HISTORIC AND DESIGN REVIEW COMMISSION

HDRC CASE NO: 2024-178
ADDRESS: 322 LAMAR ST
LEGAL DESCRIPTION: NCB 528 BLK 1 LOT 6
ZONING: R-5, H
CITY COUNCIL DIST.: 2
DISTRICT: Dignowity Hill Historic District
APPLICANT: Gustavo De La Rosa | DLR HOME SERVICES LLC
OWNER: Gustavo De La Rosa | DLR HOME SERVICES LLC
TYPE OF WORK: Roof reconstruction to include increase in overall height and rear roof form modifications
APPLICATION RECEIVED: April 12, 2024; Complete on June 28, 2024
60-DAY REVIEW: August 27, 2024

The applicant is requesting a Certificate of Appropriateness for approval to:

1 Front Elevation
SCALE: 1/4"=1'-0"

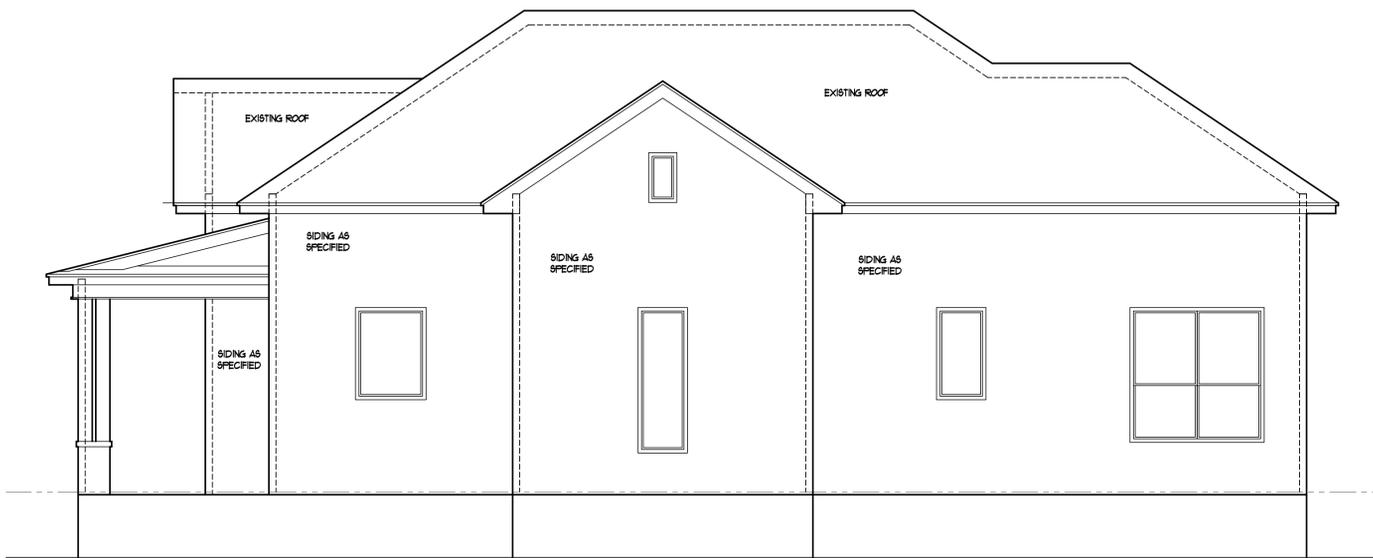
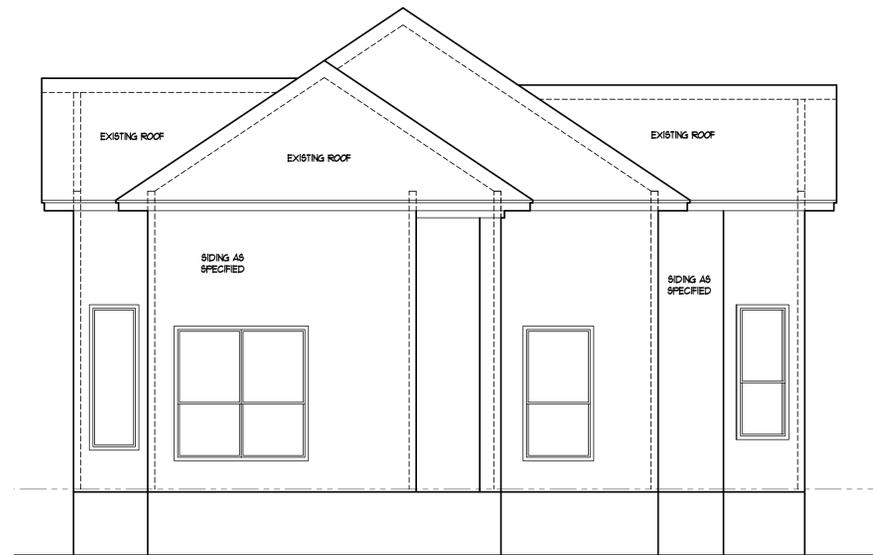
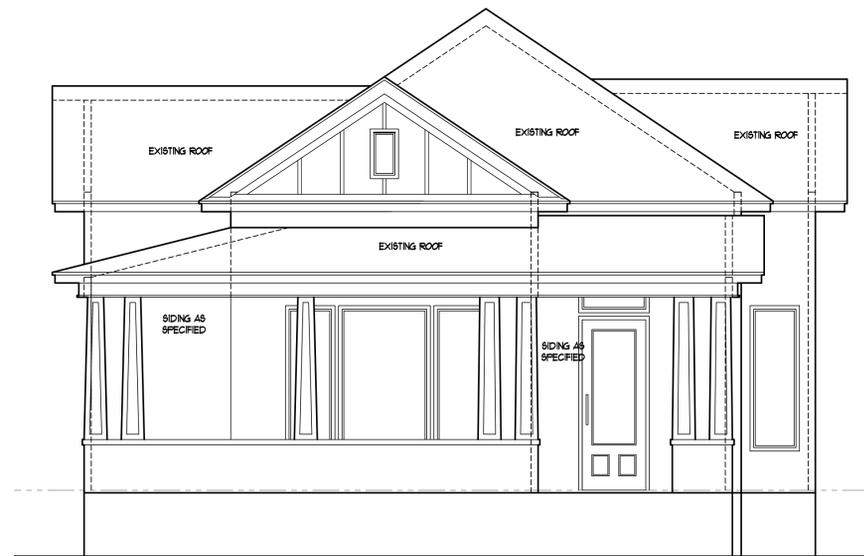
- d. **ROOF RECONSTRUCTION** – The applicant is requesting approval to remove the existing roof and roof framing and reconstruct to match the existing roof form and increase the overall height by 3 feet. The applicant has noted that a previous fire has led to the need for roof reframing. Additionally, the applicant has noted an increase of roof height is needed to accommodate code requirements and an HVAC unit. The Historic Design Guidelines for Exterior Maintenance and Alterations 3.B.ii. states to preserve the original shape, line, pitch, and overhang of historic roofs when replacement is necessary. Staff finds the proposal to increase the overall height does not conform to Guidelines; however, staff is supportive of the roof reconstruction following the historic height and configuration.

- i. That the applicant retain the existing ridge heights of the original portion at their current elevations.
- ii. That the applicant submit to staff updated construction documents accurately reflecting the items in stipulation i.

5 Roof Framing Plan
SCALE: 1/8"=1'-0"

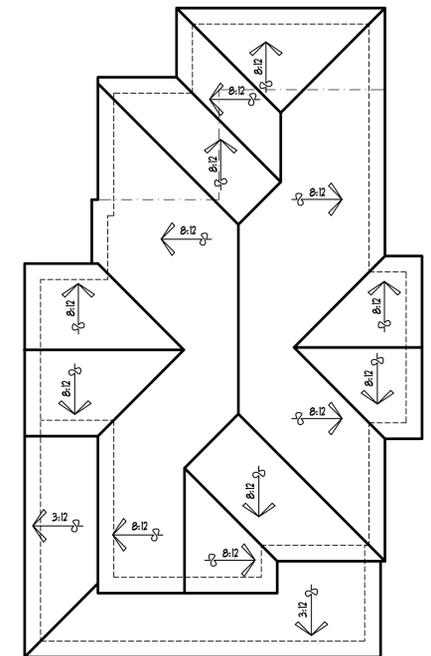
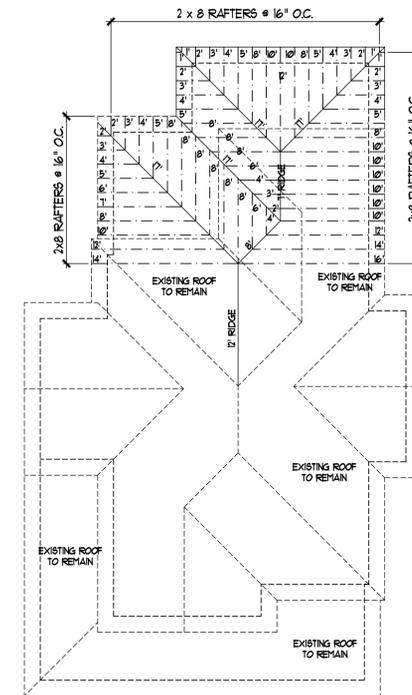
- e. **ROOF FORM MODIFICATION (POST-1951 REAR ADDITION)** – The applicant is requesting approval to modify the existing roof form of the post-1951 rear addition. A modification of this roof form would result in the removal of the existing shed roof and construction of a hipped roof. The existing post-1951 rear addition does not appear on the 1951 Sanborn Map. The applicant has noted staff the purpose of the roof form modification was to increase the interior ceiling height. Exterior Maintenance and Alterations 3.B.ii. states to preserve the original shape, line, pitch, and overhang of historic roofs when replacement is necessary. Staff finds the roof form modification of the post-1951 rear addition generally appropriate.

- f. **ROOF FORM MODIFICATION (CIRCA 1912 REAR ADDITION)** – The applicant is requesting approval to modify the existing roof form on the circa 1912 rear addition. A modification of this roof form would result in the removal of the rear-facing gable and construction of a hipped roof. This rear addition matches the footprint of a rear porch in the 1904 Sanborn Map and matches the footprint of an addition represented in the 1912 Sanborn Map. Exterior Maintenance and Alterations 3.B.ii. states to preserve the original shape, line, pitch, and overhang of historic roofs when replacement is necessary. Exterior Maintenance and Alterations 3.B.iii. states to preserve and repair distinctive roof features such as cornices, parapets, dormers, open eaves with exposed rafters and decorative or plain rafter tails, flared eaves or decorative purlins, and brackets with shaped ends. Staff finds the change in roof form of the circa 1912 rear addition generally appropriate.

Item 1: Staff recommends approval of item 1, based on findings a through d, with the following stipulations:

Item 2: Staff recommends approval of item 2, based on findings a, c, and e.

Item 3: Staff recommends approval of item 3, based on findings a, c, and f.
